*City of Portsmouth
Public Works Department*

**Addendum #1
Parrott Ave Parking Lot Project
Bid Proposal #14-16**

Issued September 17, 2015

This addendum forms part of the original document marked: **Bid Proposal #14-16 – Parrott Ave Parking Lot Paving**. Please acknowledge this addendum within your proposal, failure to do so may subject a bidder to disqualification. Failure to acknowledge receipt of the Addendum may subject the Bidder to disqualification.

CONSTRUCTION DETAILS
FOR
PARROTT AVE PARKING LOT
SITE IMPROVEMENTS
PORTSMOUTH, NEW HAMPSHIRE
AUGUST 2015

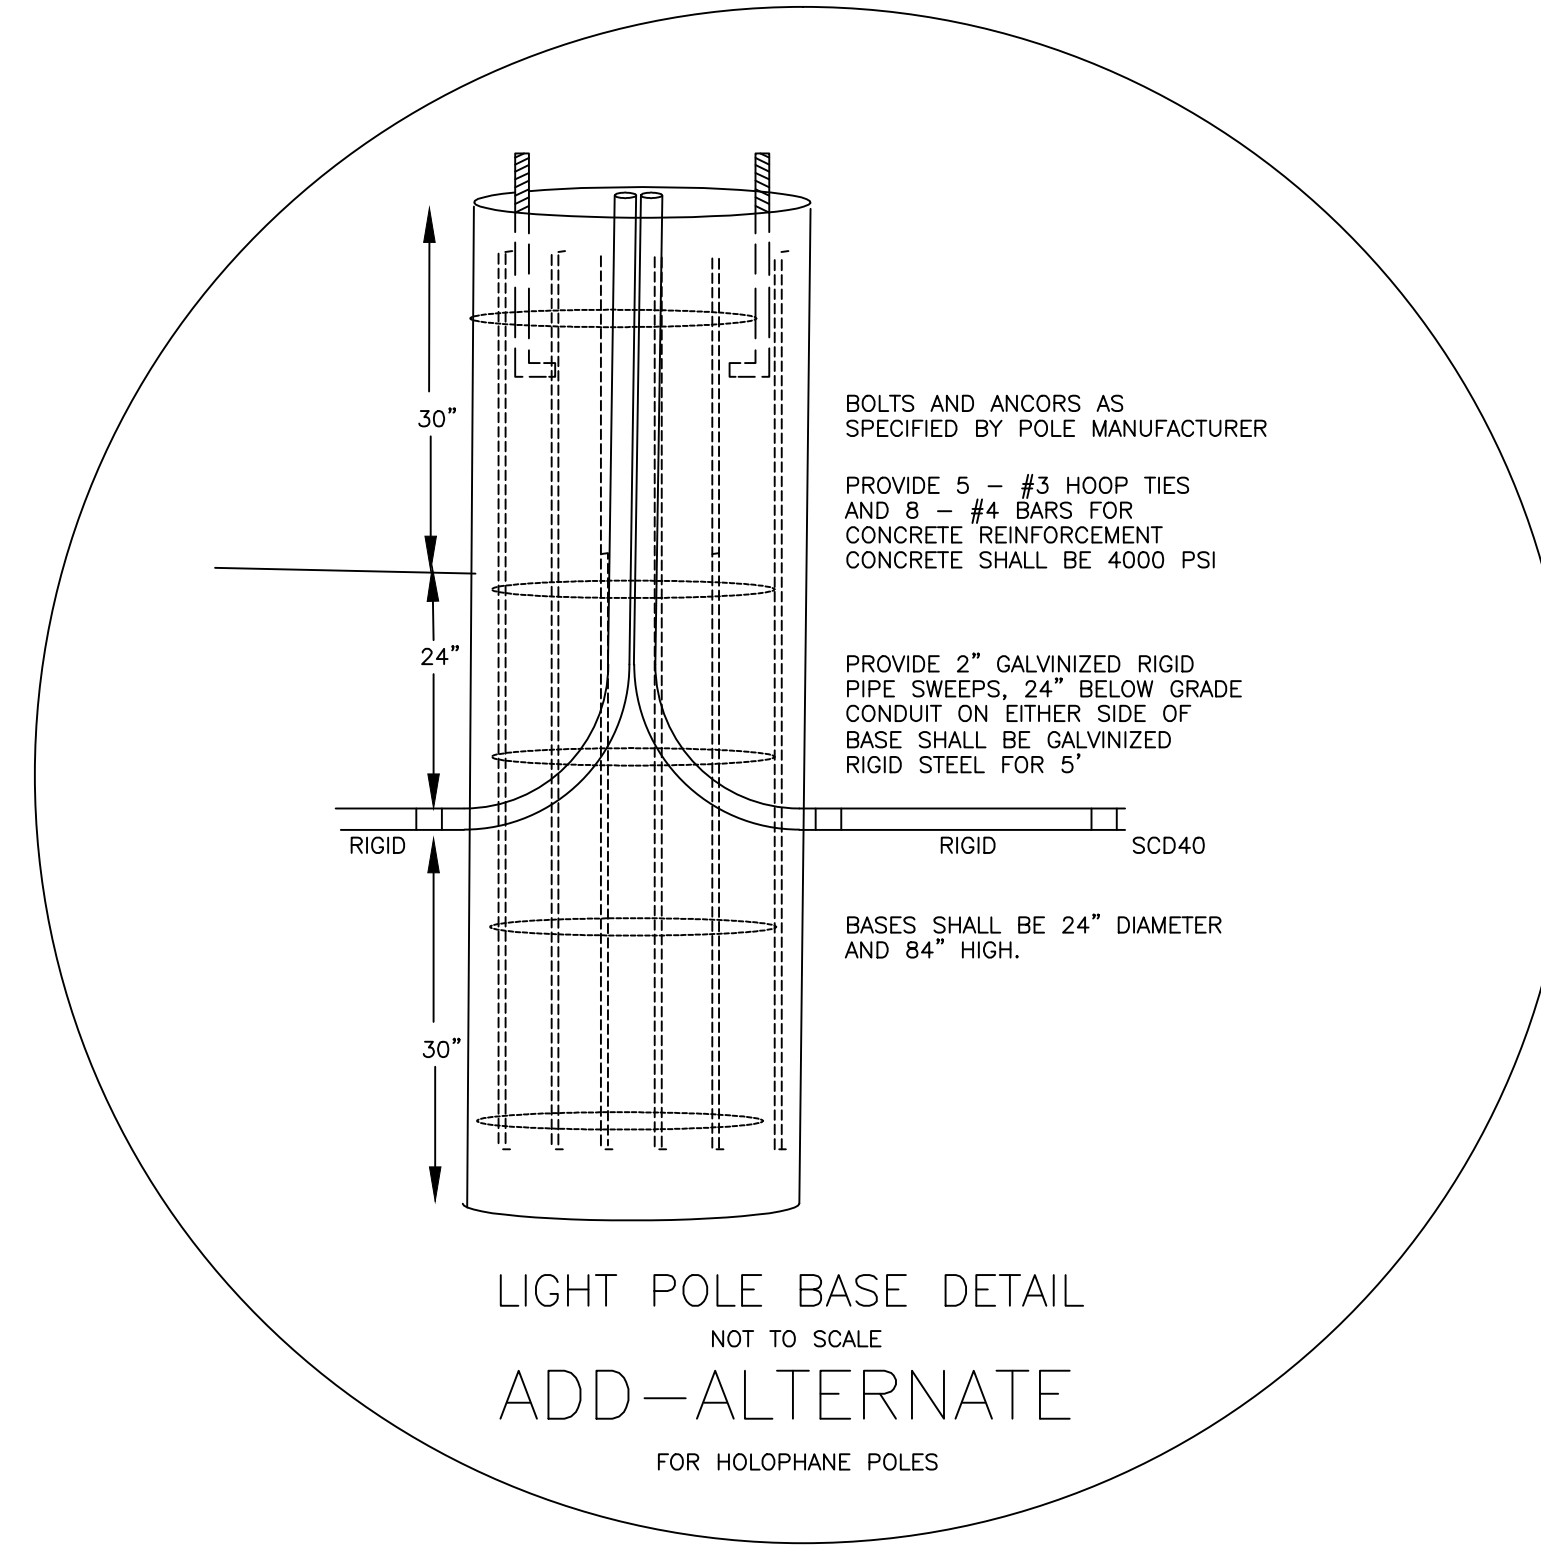
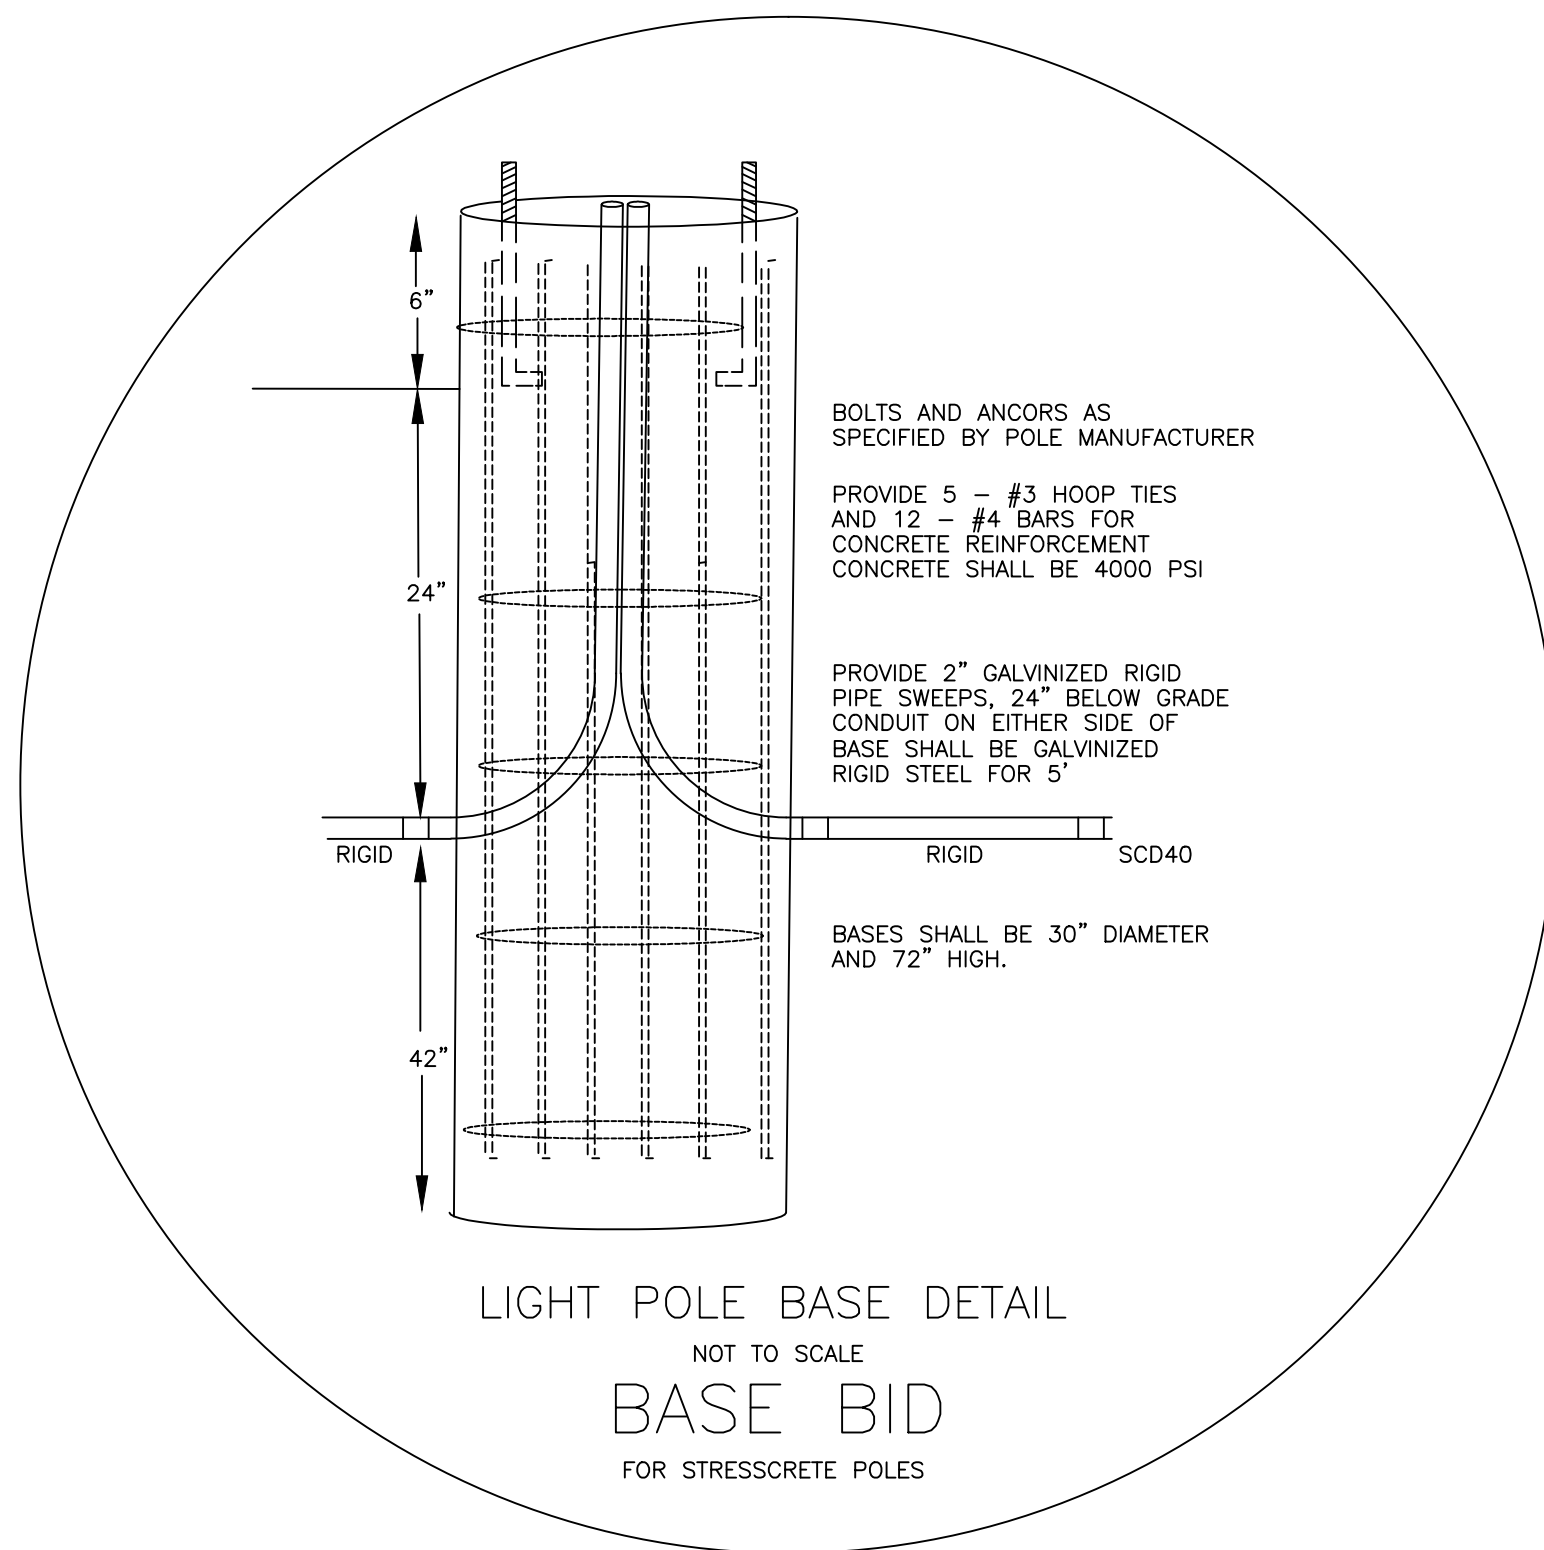
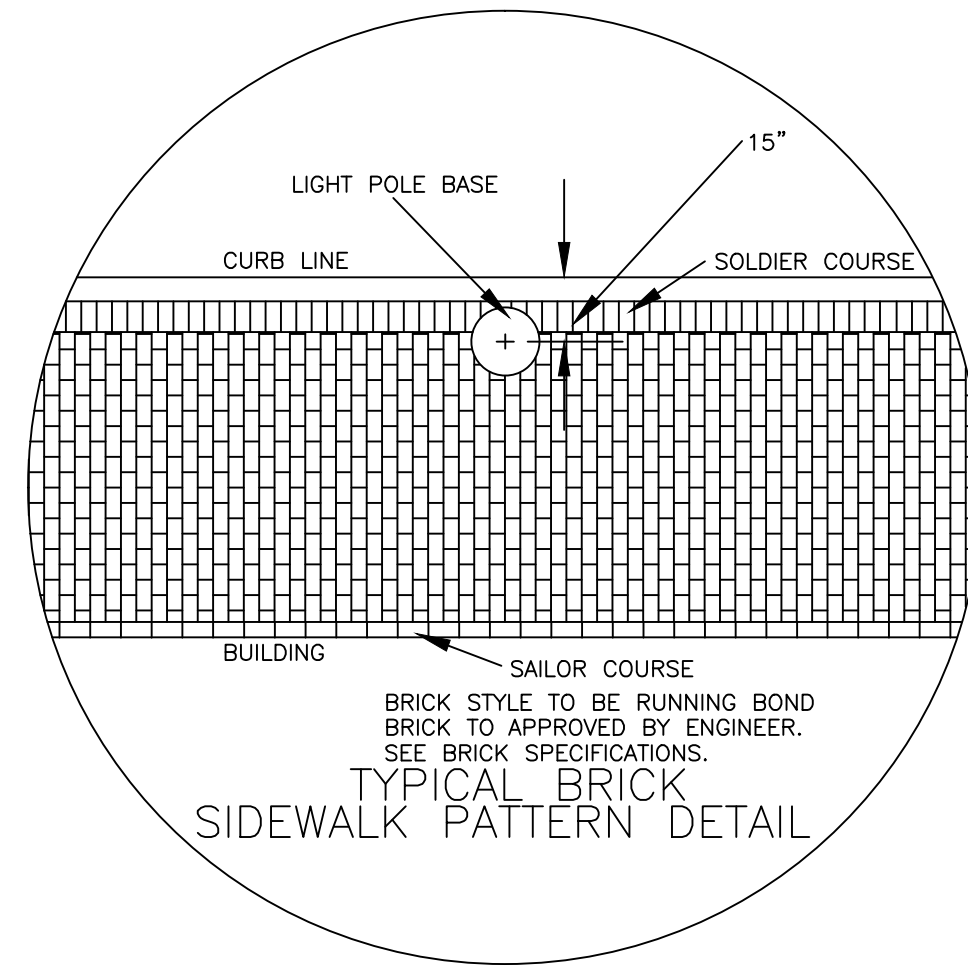
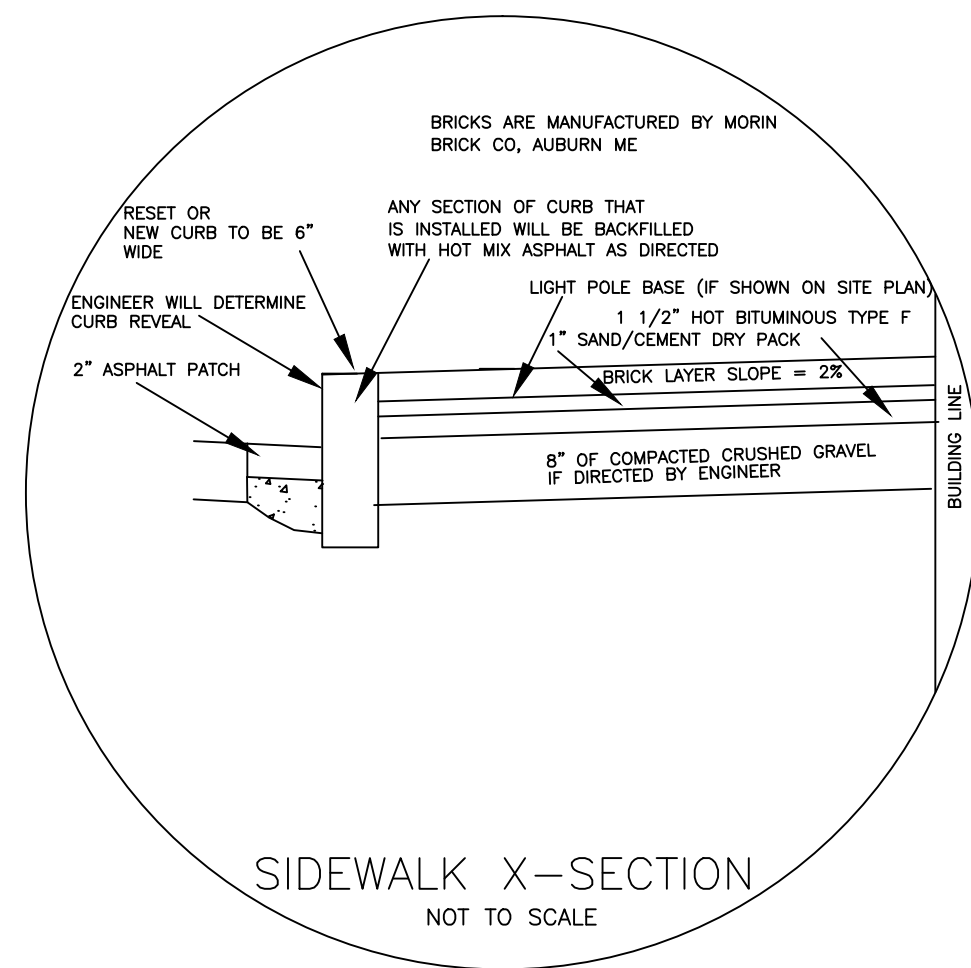
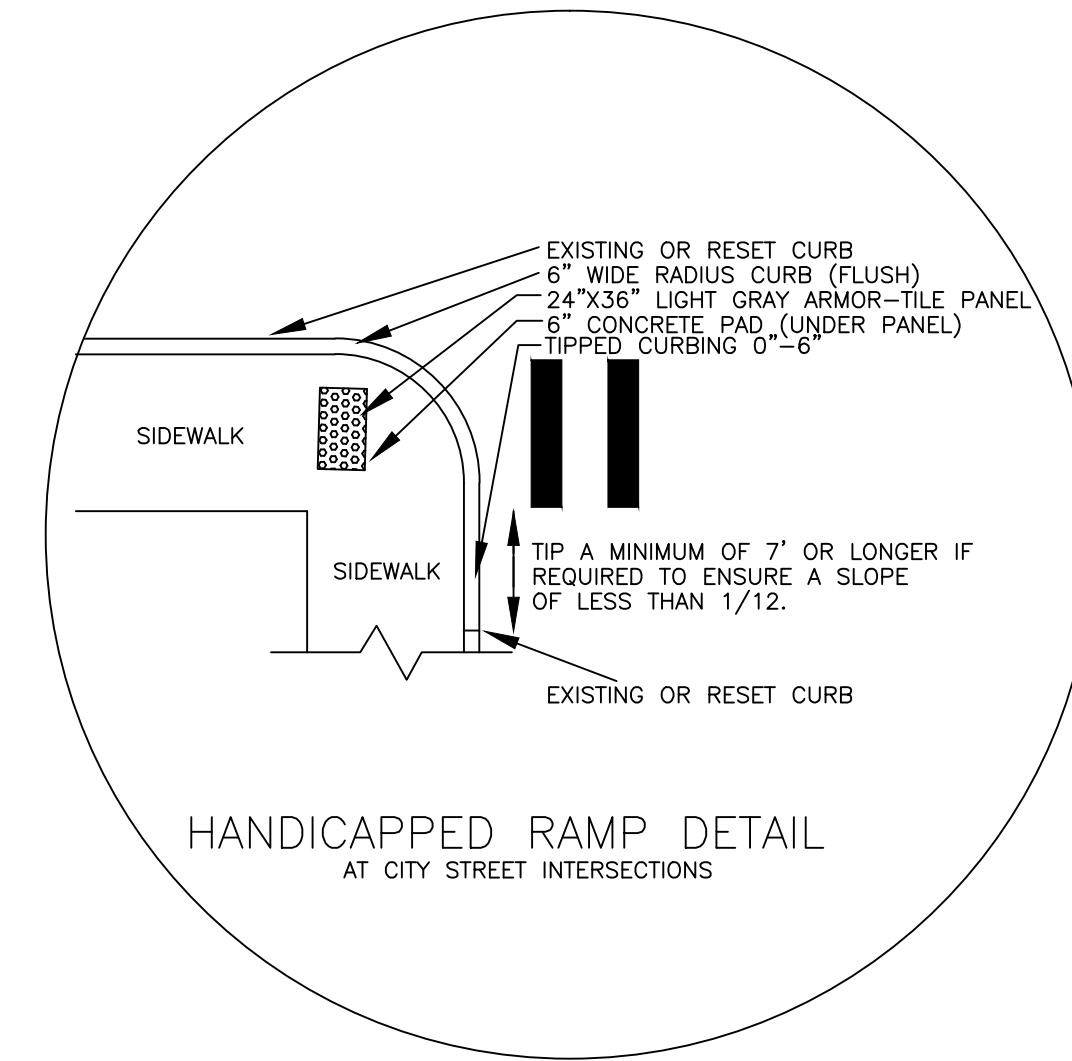
Item 1-8 Construction Details

The Light Pole Base detail has been changed to 30" diam. X 6' length to accommodate the revised light specified under the base bid.

The Light Pole Base detail for the bid alternative has been labeled as such. This is the original Light Pole Base specified for the Holophane lights which are now the Alternate Bid Item.
